6.2 Containment Systems

The information in this section of the reference ABWR DCD, including all subsections, tables, and figures, as modified by the STP Nuclear Operating Company Application to Amend the Design Certification rule for the U.S. Advanced Boiling Water Reactor (ABWR), "ABWR STP Aircraft Impact Assessment (AIA) Amendment Revision 3," dated September 23, 2010 is incorporated by reference with the following departures and supplements.

Figure 6.2-3 Feedwater Line Break Flow—Feedwater System Side of Break

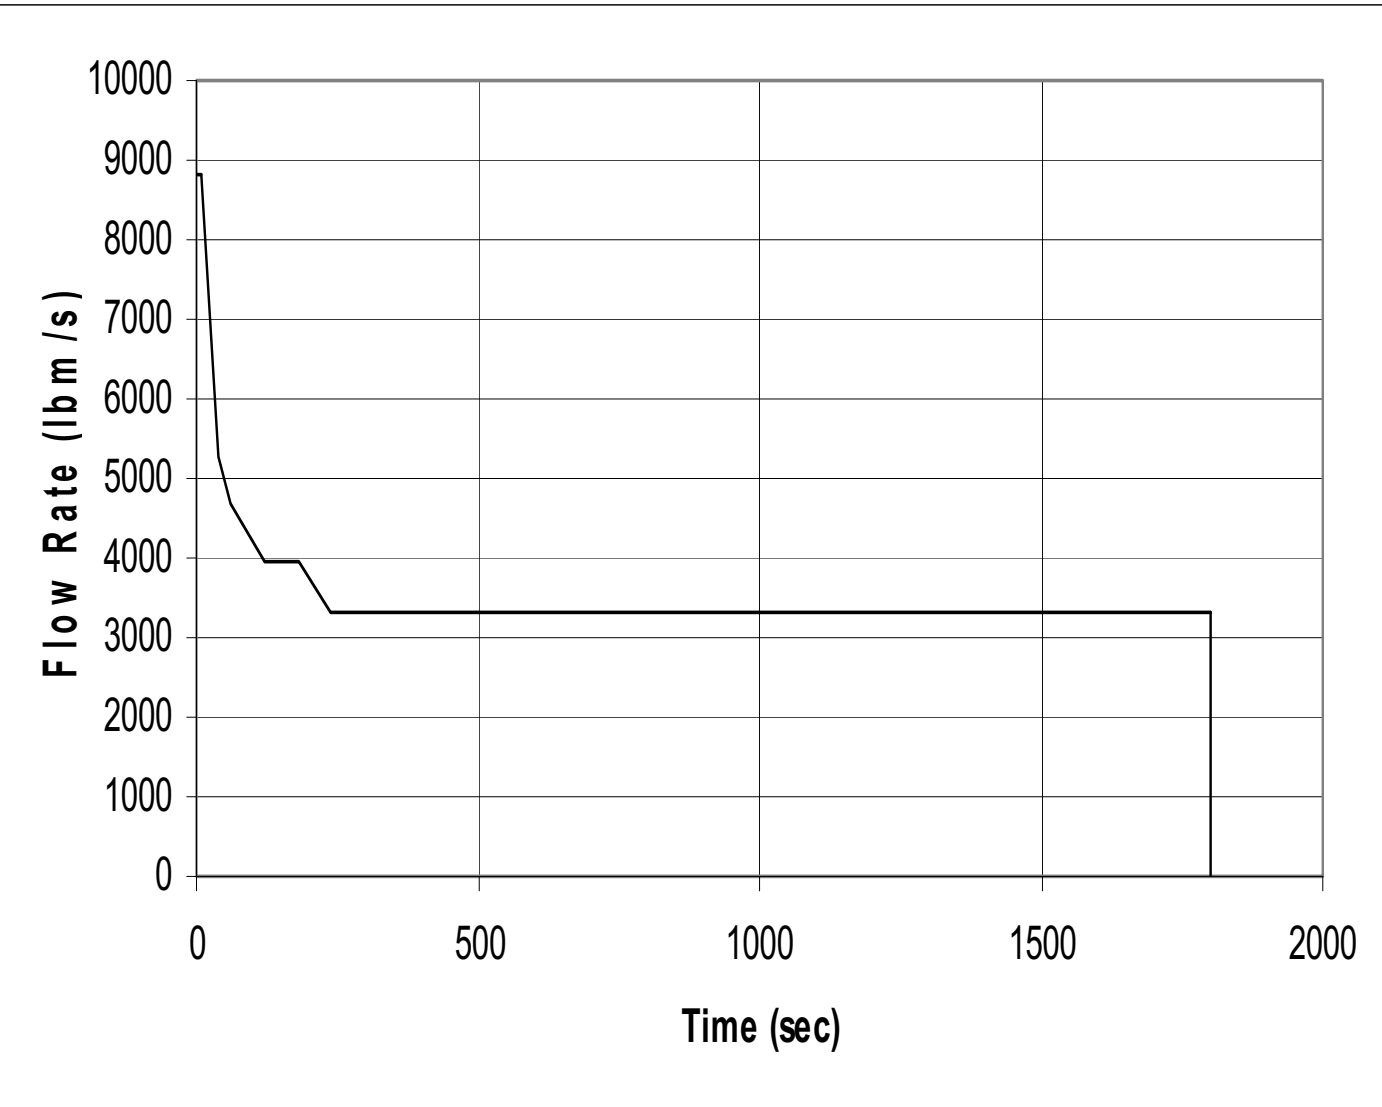
STD DEP 6.2-2 (Tables 6.2-1 and 6.2-2, Figures 6.2-2, 6.2-3, 6.2-4, 6.2-5, 6.2-6a and b, 6.2-7a and b, 6.2-8a, 6.2-8b, 6.2-8c, 6.2-9, 6.2-10, 6.2-11, 6.2-12a and 6.2-12b, 6.2-13a and 6.2-13b, 6.2-14, 6.2-15, 6.2-22, 6.2-23a, 6.2-23b, 6.2-24, 6.2-25a, and 6.2-25b.)

~~The maximum possible feedwater flow rate was calculated to be 164% of nuclear boiler rated (NBR), based on the response of the feedwater pumps to an instantaneous loss of discharge pressure. Since the Feedwater Control System will respond to decreasing RPV water level by demanding increased feedwater flow, and there is no FWLB sensor in the design, this maximum feedwater flow was conservatively assumed to continue for 120 seconds (Figure 6.2-3). This is very conservative because:~~

In order to provide further assurance of conservatism, FWLB mitigation is added to the ABWR design. The system is described in Section 7.3.1.1.2. The specific enthalpy time history, assuming the break flow of Figure 6.2-3, is shown in Figure 6.2-4. Initial reactor power is assumed to be 102% NBR.

Figure 6.2-6a Drywell Pressure Response for Feedwater Line Break

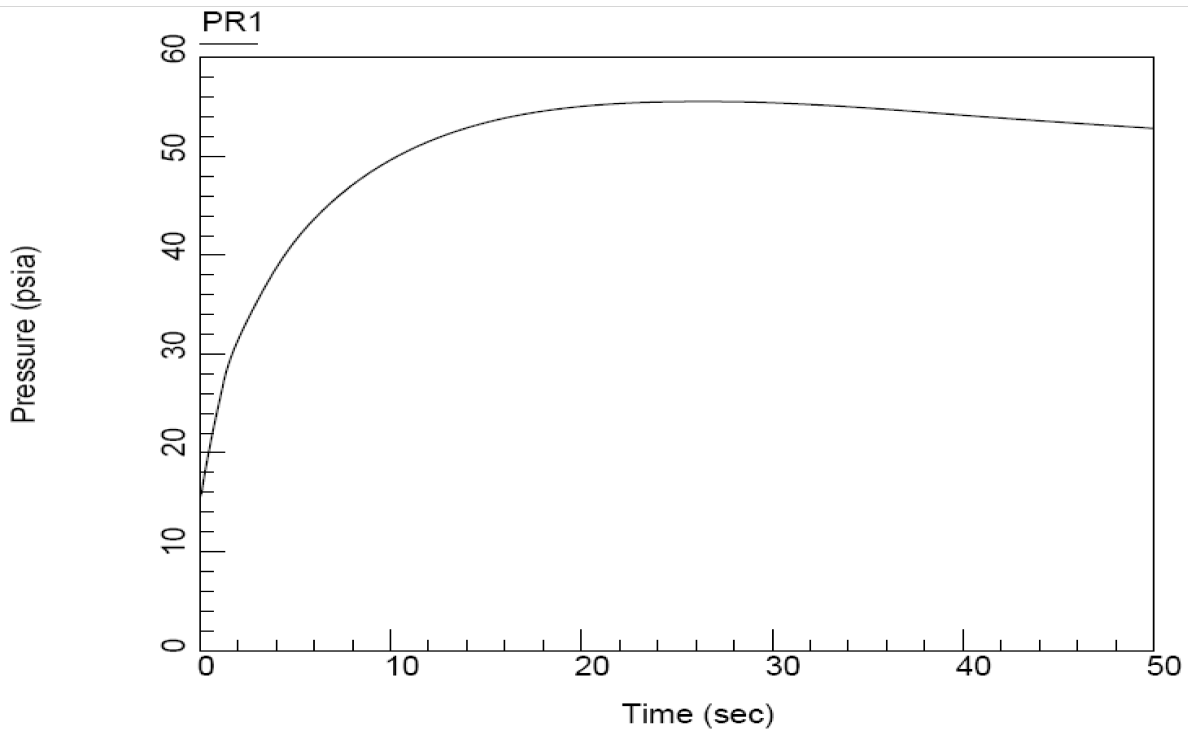
~~The calculated containment pressure and temperature responses for a feedwater line break are shown in Figures 6.2-6 and 6.2-7, respectively. The peak pressure (268.7 kPaG) and temperature (140°C) occur in the drywell. The containment design pressure of 309.9 kPaG is 115% of the peak pressure.~~

The short term pressure peak (268.7 kPaG) of Figure 6.2-6 is the peak pressure for the whole transient. Figure 6.2-8 shows temperature time histories for the suppression pool, wetwell, and drywell temperatures. The peak pool temperature (99.6°C) is reached at 6600 seconds (1.833 hours). This is less than the suppression pool temperature value of 100°C which is used in the net positive suction head available (NPSHA) calculations for RHR and HPCF.

The maximum drywell pressure occurs in the case of a feedwater line break (~~268.7~~281.8 kPaG). The design pressure for the drywell (309.9 kPaG) includes 16%approximately 10% margin.

Figure 6.2-9 ABWR Main Steamlines with a Break

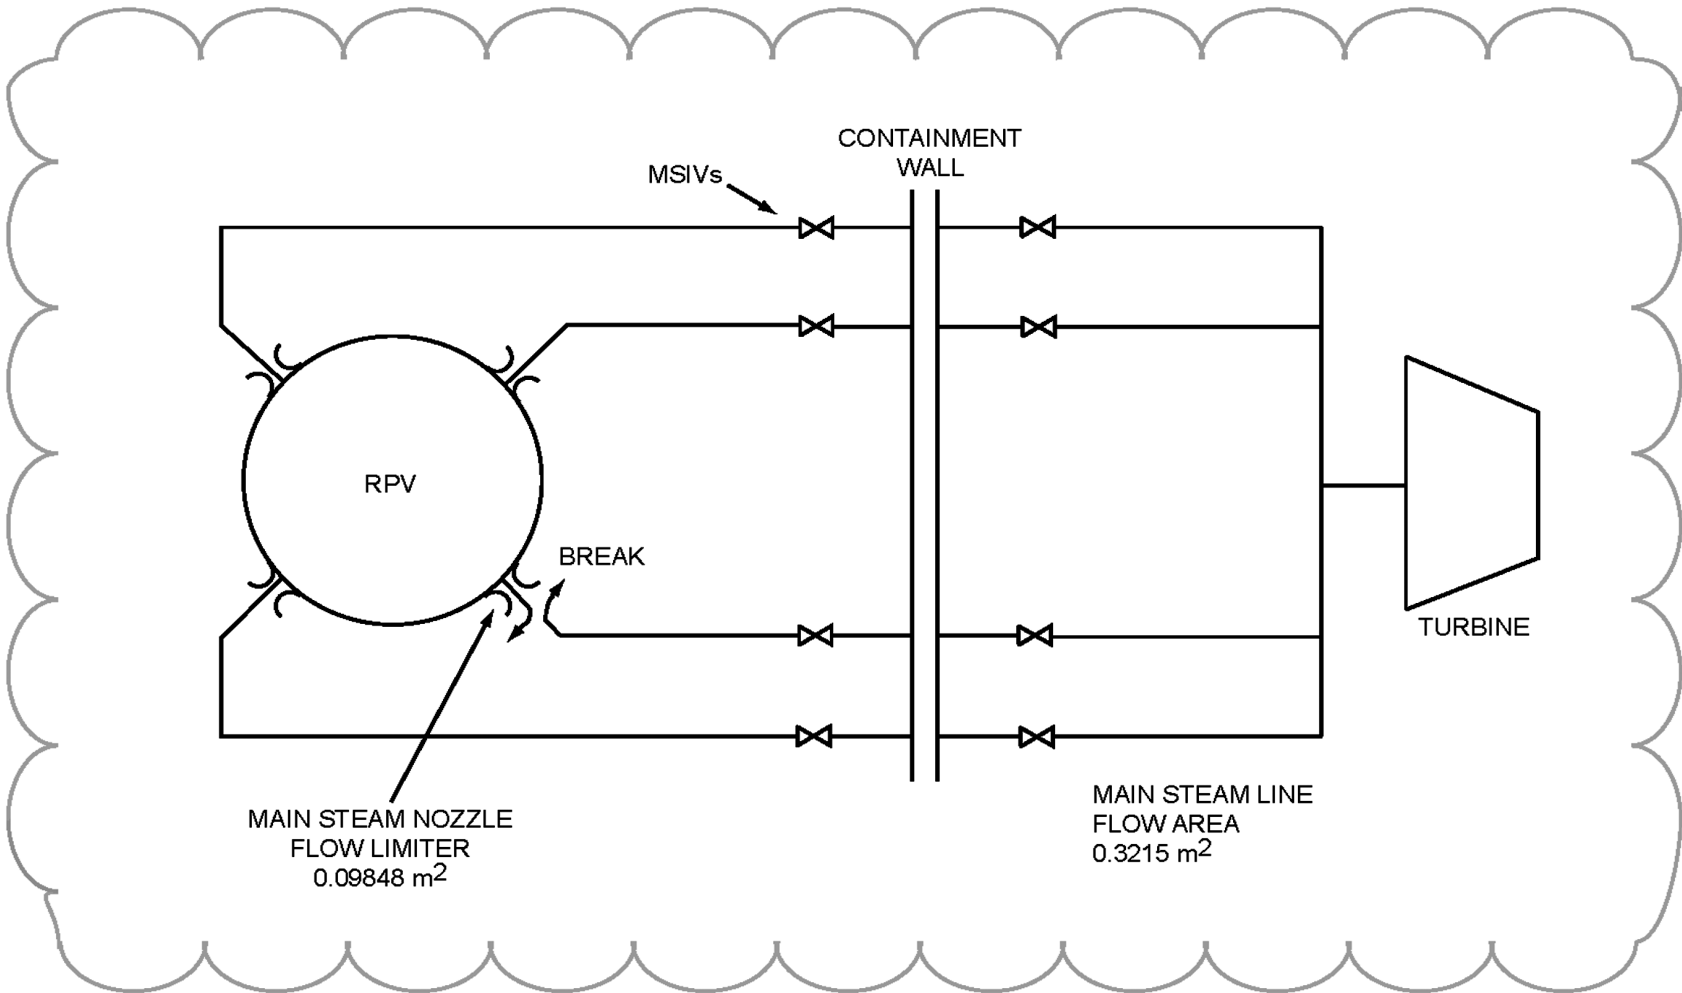
A schematic of the ABWR main steamlines, with a postulated break in one of the main steamlines, is shown in Figure 6.2-9. The main steamline (MSL) break is a double-ended break with one end fed by the RPV directly through the broken line, and the other fed by the RPV through the unbroken main steamlines until the MSIVs are closed. Once the MSIVs are closed, the break flow is only from the RPV through the broken line.

Each MSL contains a flow limiter built into the MSL nozzle on the RPV with a throat area of 0.09848 m², as shown in Figure 6.2-9. This flow limiter provides the effective break area for the vessel side.

- (1) Each MSL contains a flow limiter built into the MSL nozzle on the RPV with a throat area of 0.0983m², as shown in Figure 6.2-9.*
- (2) The break is located in one MSL at the inboard MSIV.*
- (3) During the inventory depletion period, the flow multiplier of 0.75 is applied (Reference 6.2-1).*
- (4) The flow resistance of open MSIVs is considered. A conservative value of 2.062 for pressure loss coefficient for two open MSIVs was taken. The nominal value is approximately 3.0. When the open MSIV resistance is considered, the flow chokes at the MSIV on the piping side as soon as the inventory depletion period ends. The effective flow area on the piping side reduces to 70% of a frictionless piping area. The value of 70% applies to flow of steam and twophase mixture with greater than 15% quality.*

Figure 6.2-12a Drywell Pressure Time History for MSLB

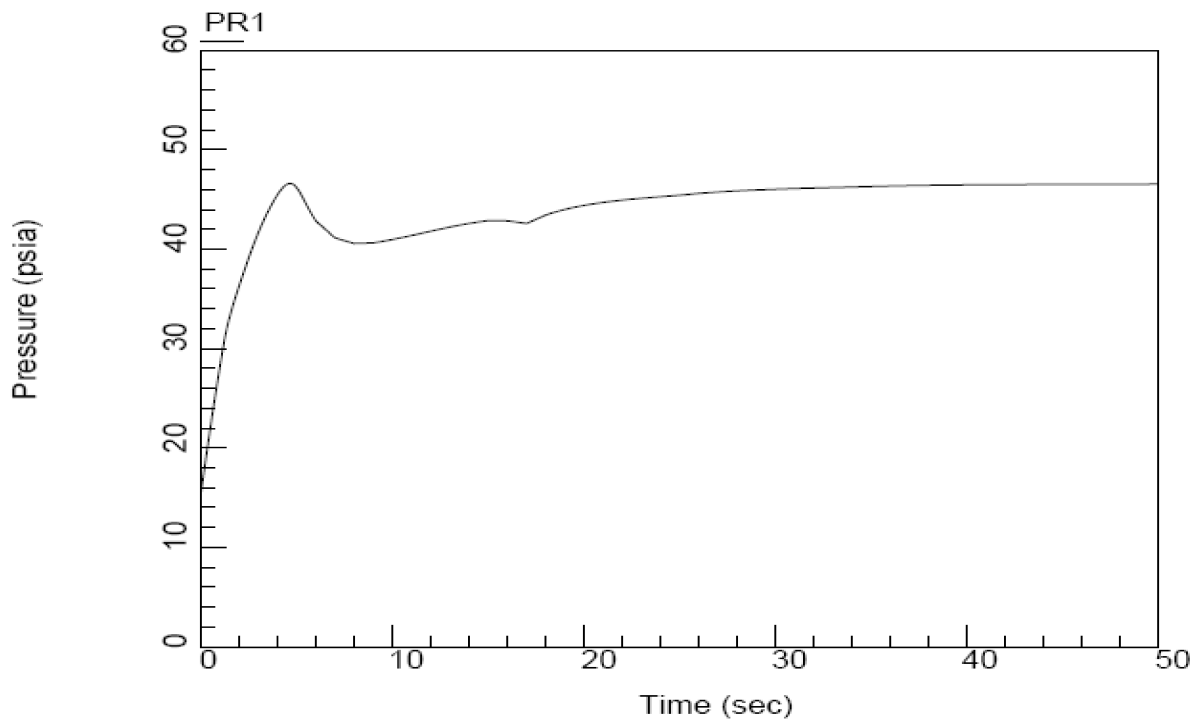
Figures 6.2-12 through 6.2-15 and 6.2-13 show the pressure and temperature responses of the drywell and wetwell during the blowdown phase of the steamline break accident.

Figure 6.2-13a Drywell Temperature Time History for MSLB

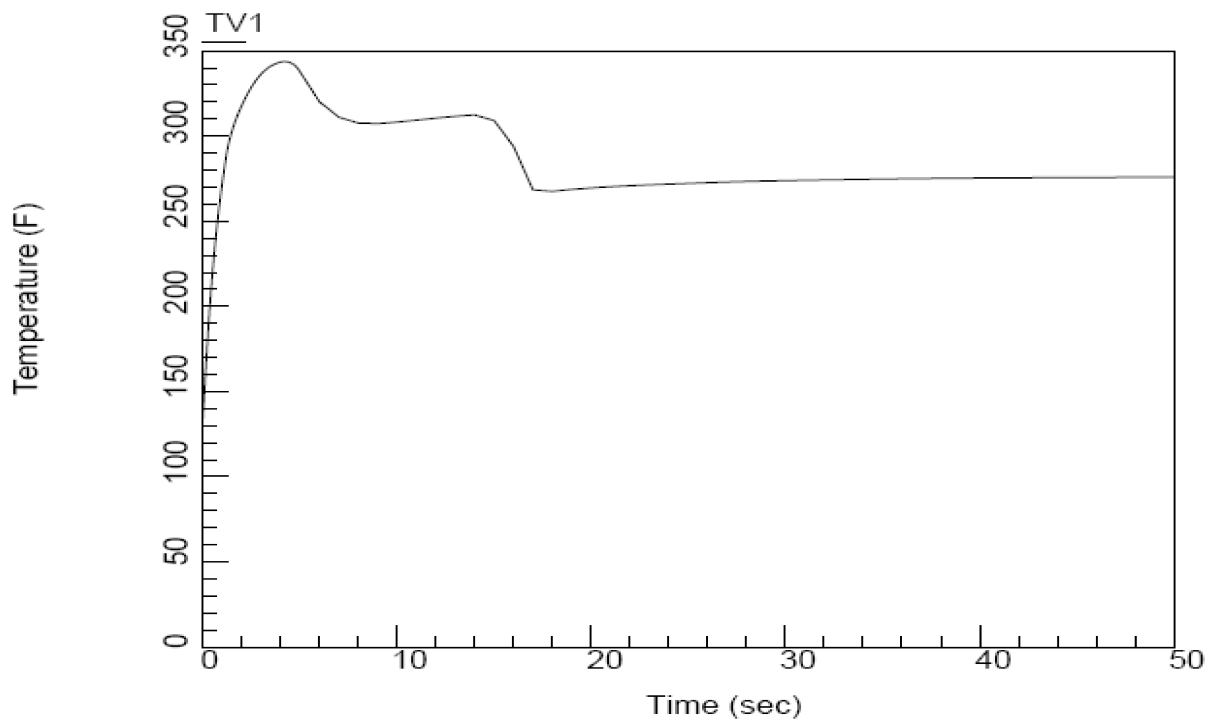
The maximum drywell temperature (173.2°C) is predicted to occur for the steamline break. The MSLB with two-phase blowdown starting when the RPV collapsed water level is at or below the main steamline nozzle provides the highest peak drywell temperature. The peak drywell air temperature is 169.7/173.2°C, below the which is above the design value of 171.1°C, and is the limiting one as compared to the FWLB peak temperature. As noted in Section 6.2.1.1.2.1, this peak calculated drywell temperature exceeds the design limit for only 2 seconds. The peak drywell pressure for the MSLB remains below that for the FWLB, which becomes the most limiting. The peak drywell pressure is below the design pressure. The MSLB is the limiting event for peak drywell temperature. The FWLB is the most limiting for drywell pressure.

~~The long term containment pressure and temperature responses following the MSLB accident remain below those for the feedwater line break, which is the most limiting event.~~ The long-term containment pressure response following the MSLB accident remains below that for the feedwater line break. The long-term temperature response remains below that for the peak achieved in the short term for the steam line break shown in Figure 6.2-13.
